NIGHT CLUB RENOVATIONS
FOR JSG MIAMI ENTERTAINMENT LLC

1235 WASHINGTON AVE. WASHINGTON AVE
MIAMI BEACH, FL

**NARRATIVE RESPONSE
PROCESS #BC2117476
NIGHTCLUB @ 1235 WASHINGTON AVENUE
BRANDT BUILDING**

BC2117476 1235 WASHINGTON AVE Miami Beach, FL 33139-4613
11/09/2021

MECHANICAL FLOOR PLANS
SHEET 1 OF 1

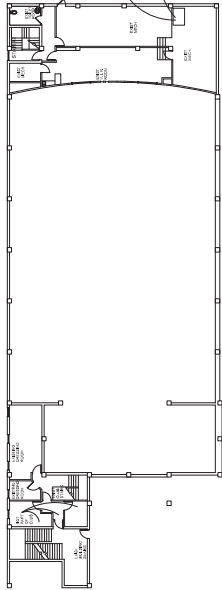
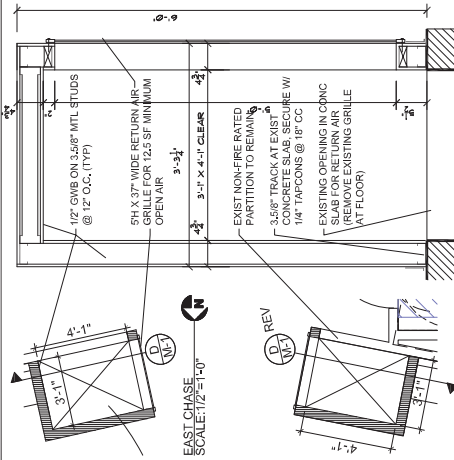
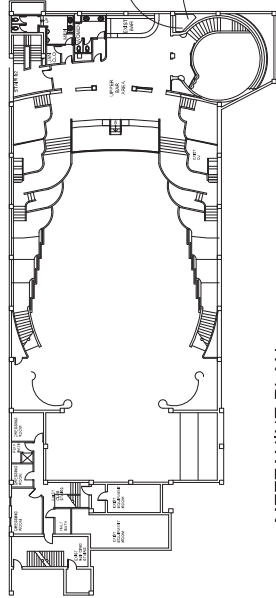
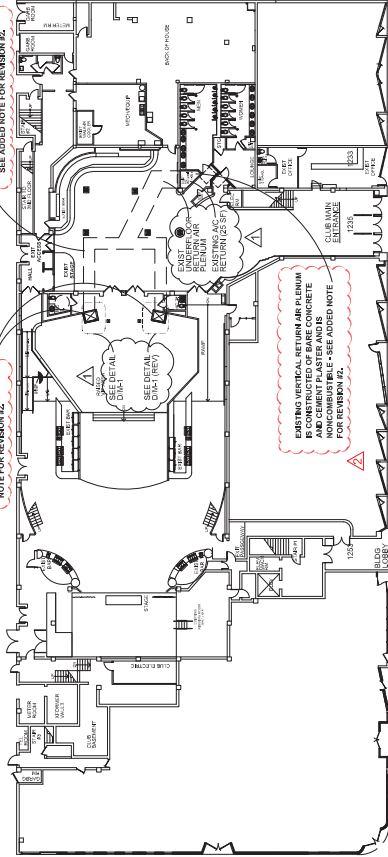
In order to properly evaluate response to comments,
provide a narrative showing location of corrections
(Sheet XX, Floor Plan or Sheet XX, Note #, etc.).

Cloud-in and number in bold the latest revision number.

1. Comply with FBC-M 602.2.1 (materials within plenums). Materials within plenums shall be noncombustible or shall be listed and labeled as having a flame spread index of not more than 25 and a smoke-developed index of not more than 50 when tested in accordance with ASTM E84 or UL 723. Provide note on the plans and remove materials that do not comply. Verify that no fire-rated assemblies are penetrated. If so, provide fire/smoke dampers and update "HVAC Design Requirements" table.

RESPONSE: SEE THIS NARRATIVE AND SHEET M-1, REVISION #2, 11/11/21.

RESPONSE: ALL REVISIONS ARE CLOUDED IN RED, WITH REVISION #2 MARK, AND THE SHEET IS NOW DATED 11/11/21.

RESPONSE: SEE ADDED NOTES ON SHEET M-1 THAT STATE THE NEW AND EXISTING RETURN AIR PLENUMS ARE CONSTRUCTED OF NON-COMBUSTIBLE MATERIALS, THAT NO COMBUSTIBLE MATERIALS SHALL BE ALLOWED IN RETURN PLENUMS, AND THAT NO FIRE-RATED ASSEMBLIES ARE PENETRATED.
